Dynamic Information Migration

VM migration reference diagram

Associate/Deassociate in diagram

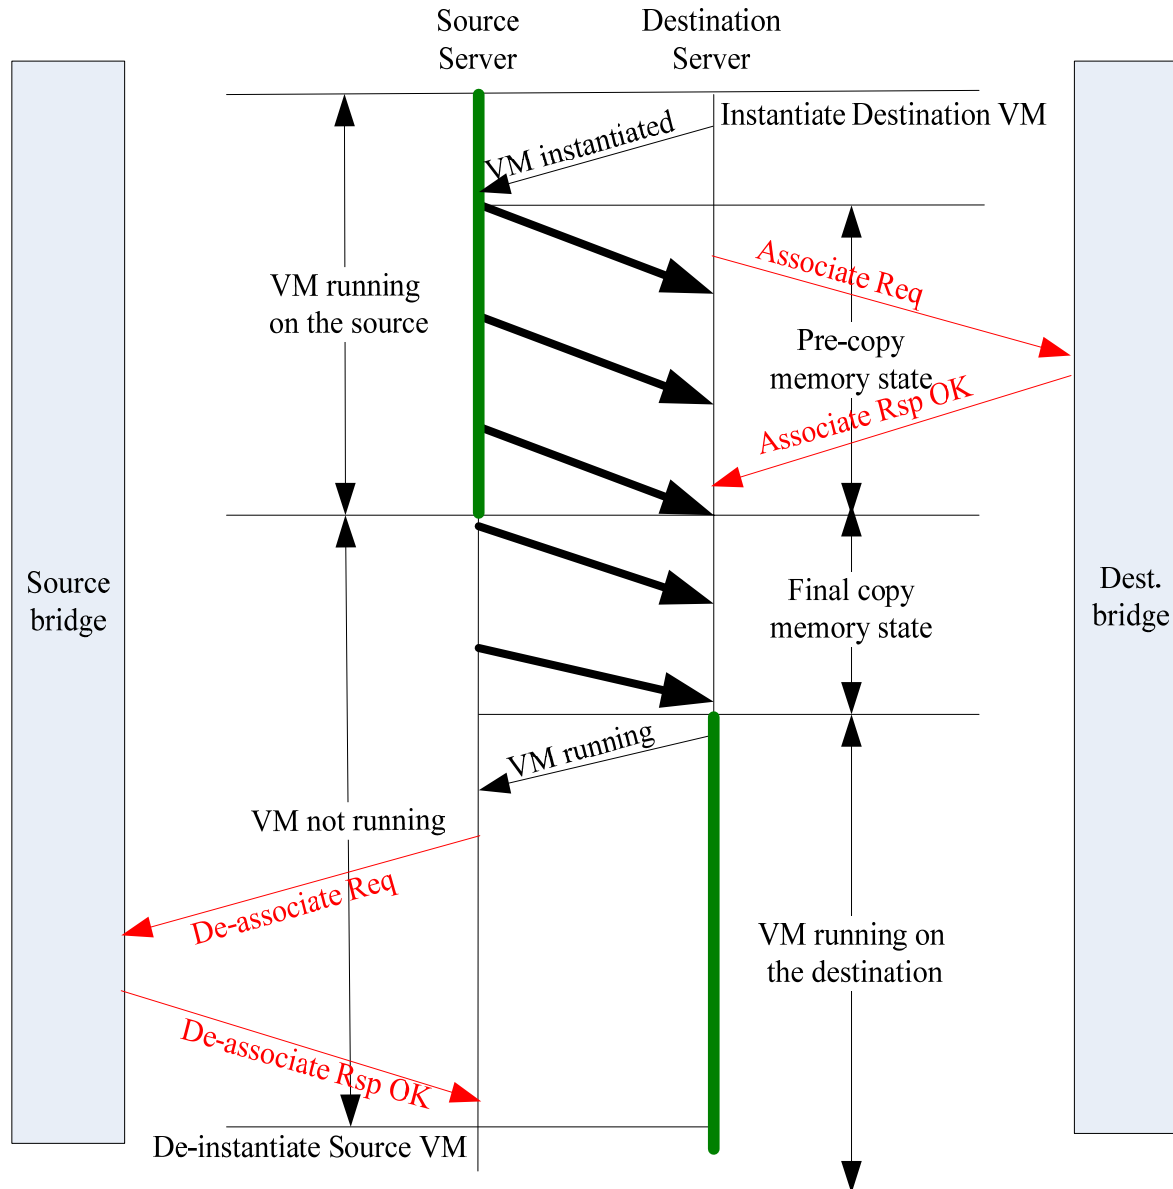
Or? (minor point)

De-instantiate of source VM should not occur until after de-associate completes???

Are Association and VM Instantiation are necessarily related?

Associate should not be requested until VM has been instantiated??

Again, I don't think this is necessary, but maybe someone can clarify.

Mike Krause suggestion to serialize

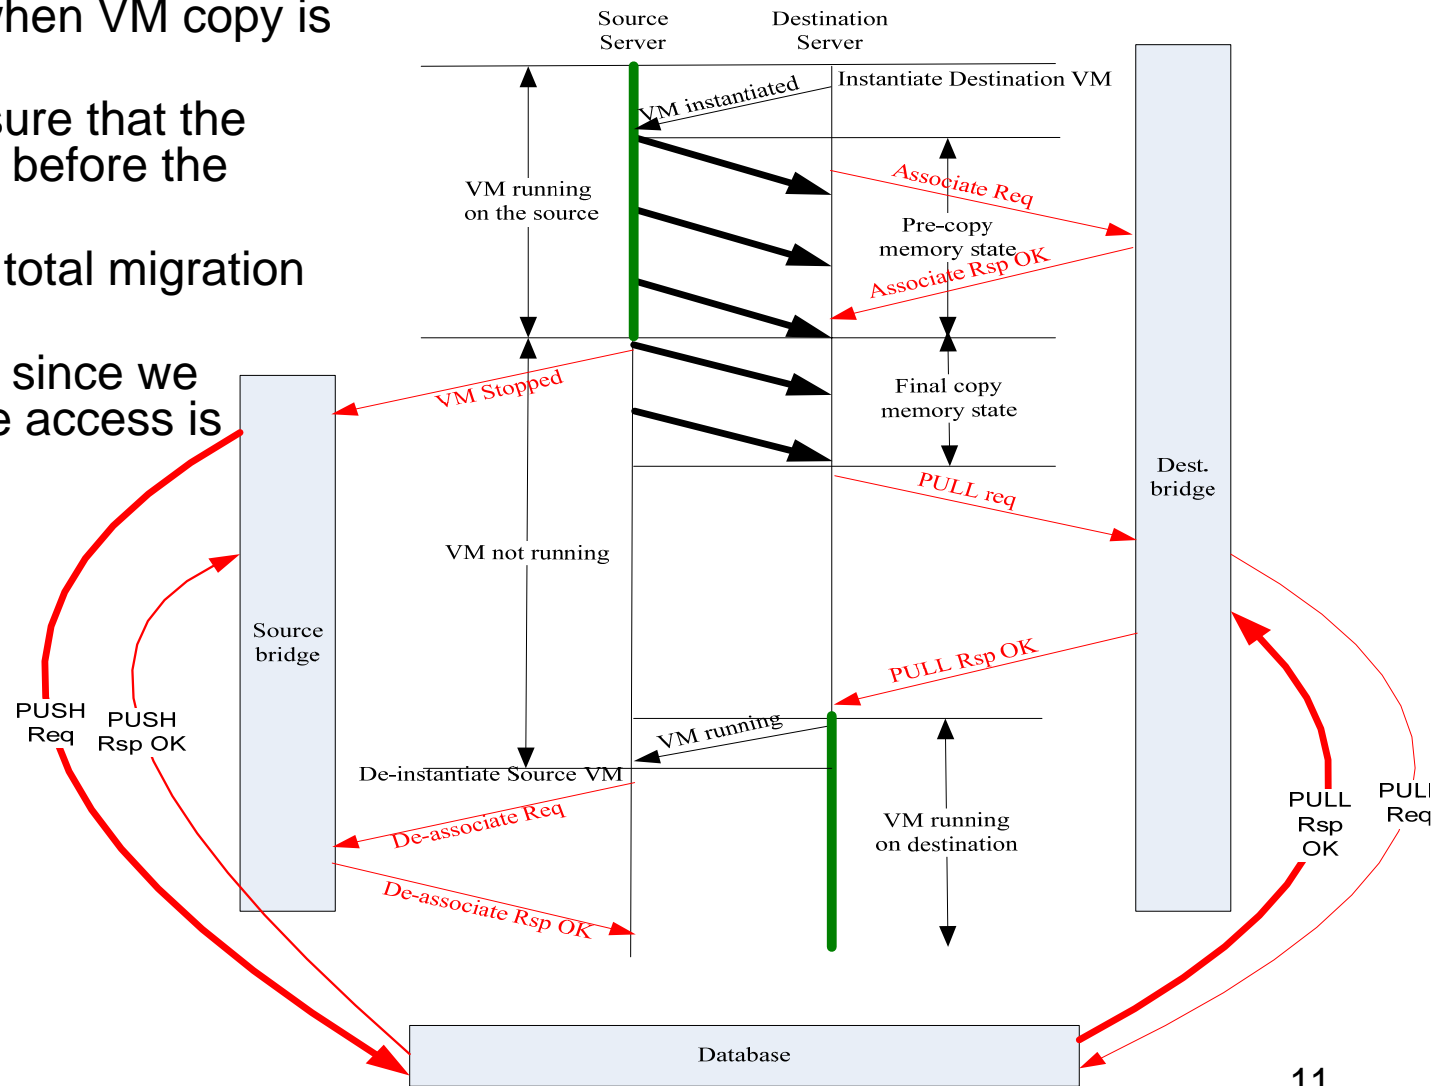
- PUSH triggered when Source VM stops;
- PULL triggered when VM copy is complete???
- Purpose is to ensure that the PUSH completes before the PULL???
- Results in longer total migration time;
- Benefit isn't clear since we assume database access is asynchronous;
